RE: Prairie Point West (fka Kings Point Northwest) ISP 6th Submission Review Response to Comments

PRAIRIE POINT (FKA KINGS POINT NORTH)
WEST INFRASTRUCTURE SITE PLAN

PRAIRIE POINT WEST ISP	DATE: 02/17/2023
WEST INFRASTRUCTURE SITE PLAN COVER SHEET	JOB NO: 12187.61
SCALE AS NOTED	
1 of 53

12 of 53

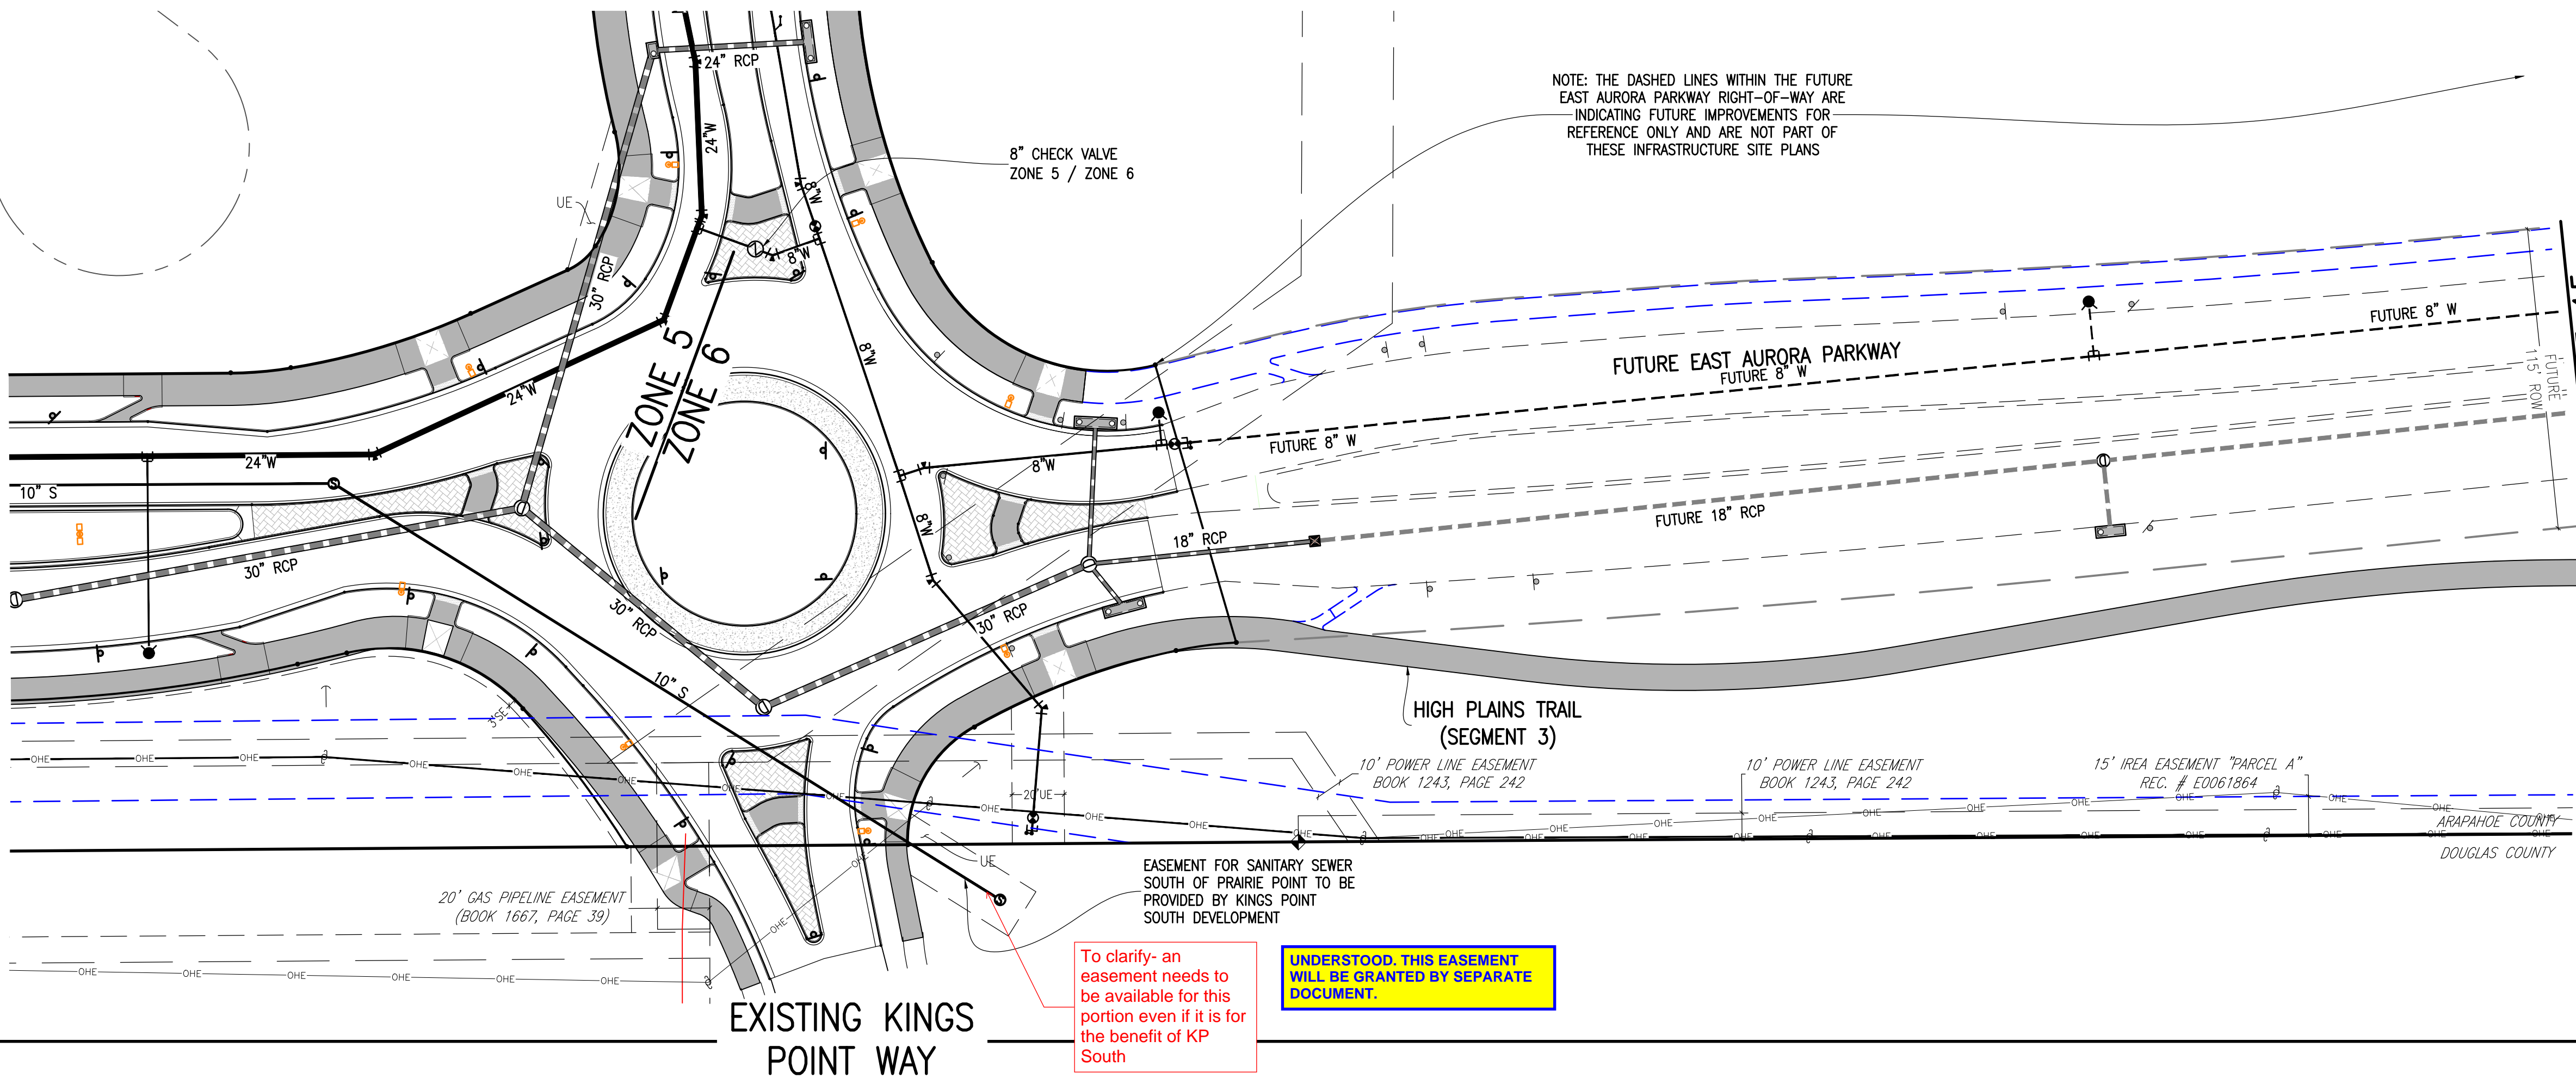
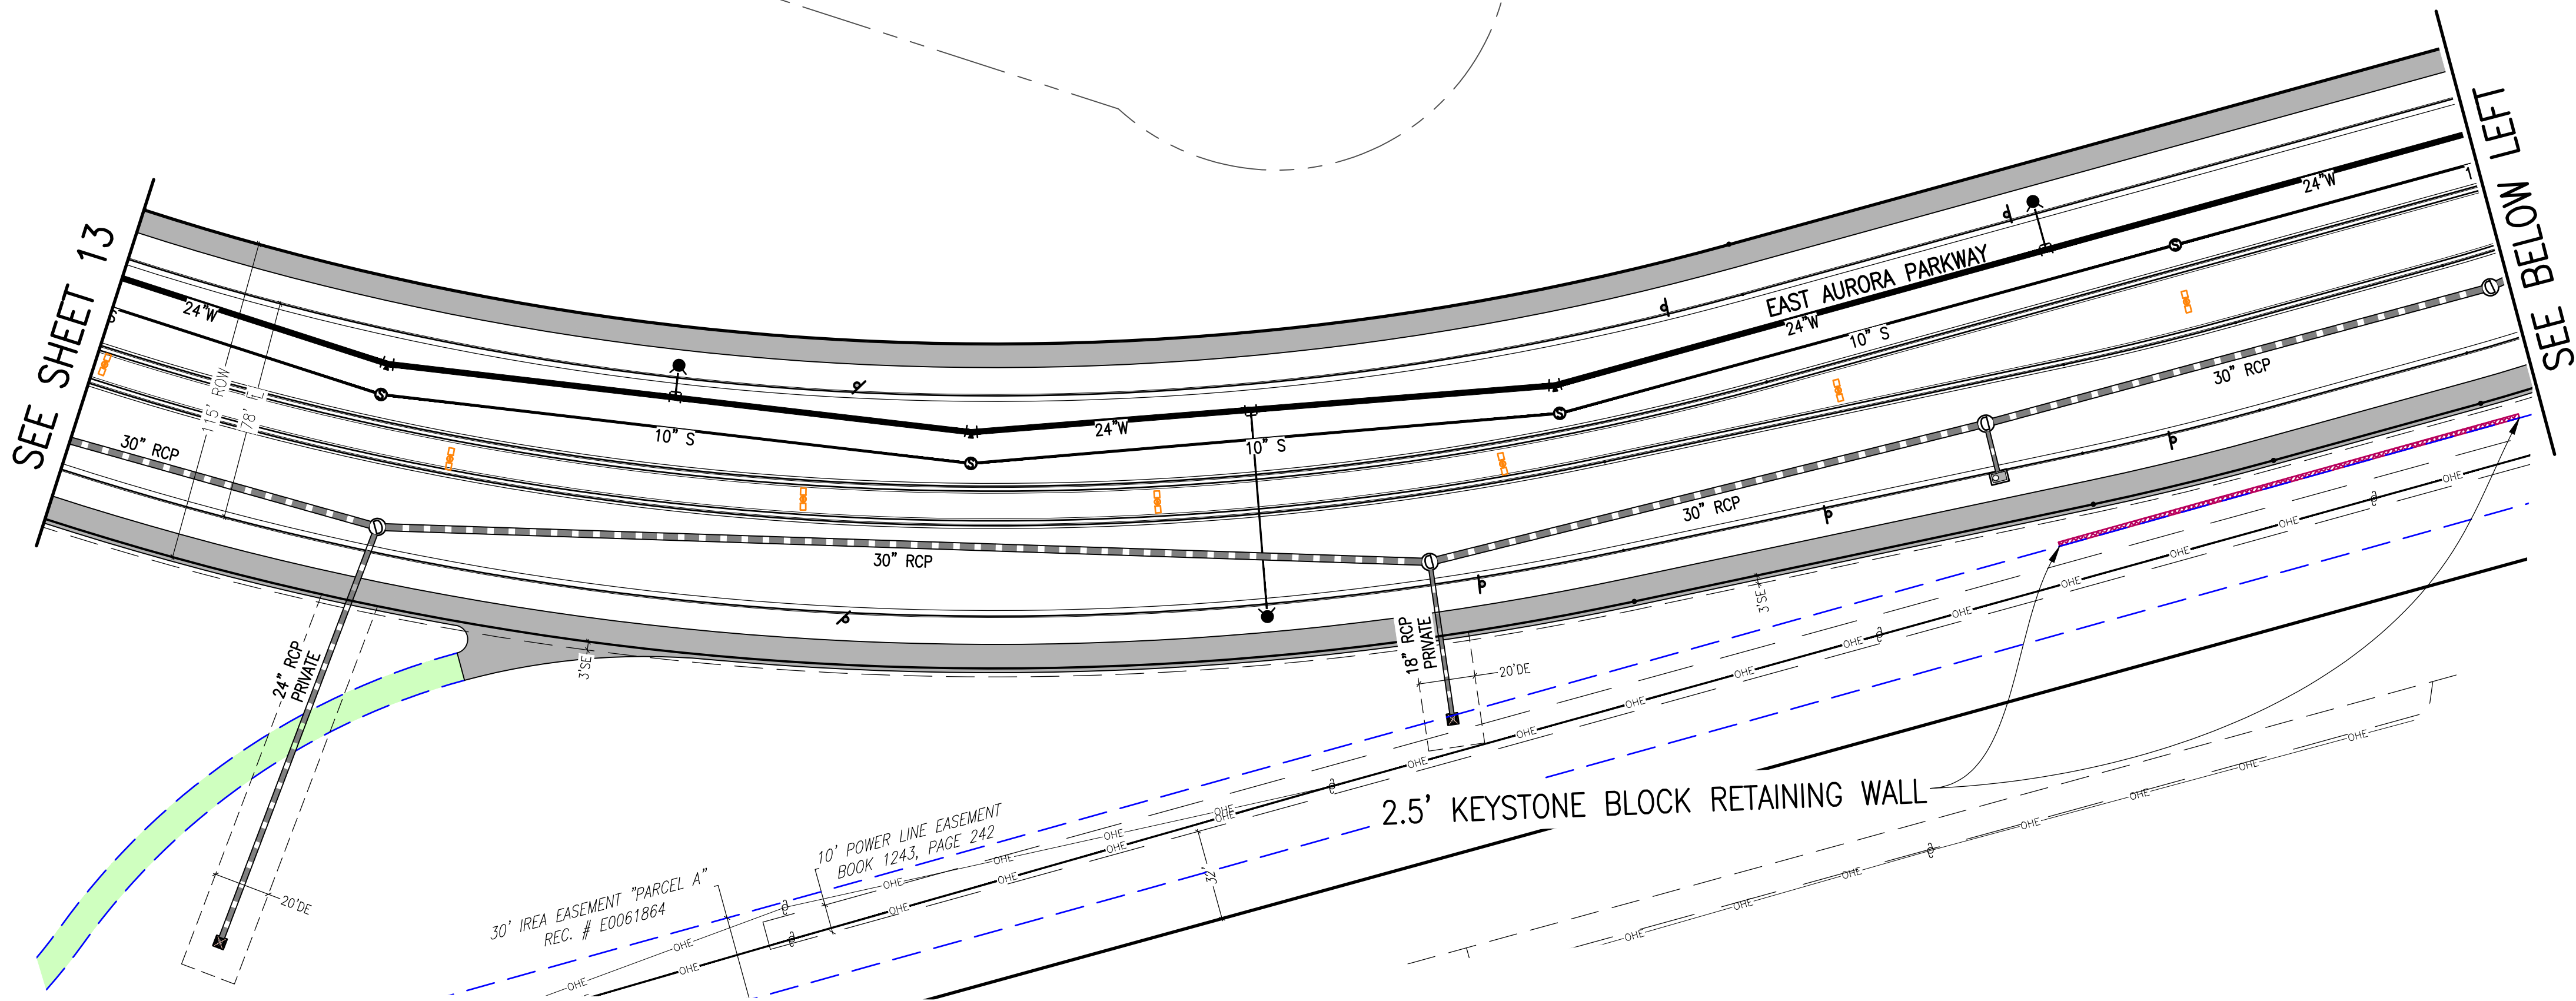
- a. As of 3/2/23, PDR not approved.
RESPONSE: THE PDR WAS RESUBMITTED ON 3/31/2023.
- [ISP Page 12]
- b. A portion of this 24" appears to be outside of ROW please adjust or include within appropriate utility easement.

RESPONSE: AN EASEMENT WILL BE GRANTED BY SEPARATE DOCUMENT.
 - c. Delineate who will own and maintain this 24" line. Delineate CDOT ROW, per email with Vern.

- d. In regard to the future civil plans- please provide documentation that CDOT has not concerns with connection of RCP line to their storm system.
RESPONSE: AT CDOT'S REQUEST, WE HAVE MOVED THE JUNCTION STRUCTURE TO INSIDE CDOT RIGHT-OF-WAY AS THEY WILL MAINTAIN THE STRUCTURE AND THE EXISTING CMP's. THE CITY AND / OR THE METRO DISTRICT WILL MAINTAIN THE RCP PIPES.
[ISP Page 14]

RESPONSE: THE WATER LINE IS TO BE OWNED AND MAINTAINED BY THE CITY. BECAUSE OF UTILITY CONFLICTS, WE HAVE MOVED THE LINE OUTSIDE OF THE CDOT RIGHT-OF-WAY. AN EASEMENT WILL BE GRANTED BY SEPARATE DOCUMENT.
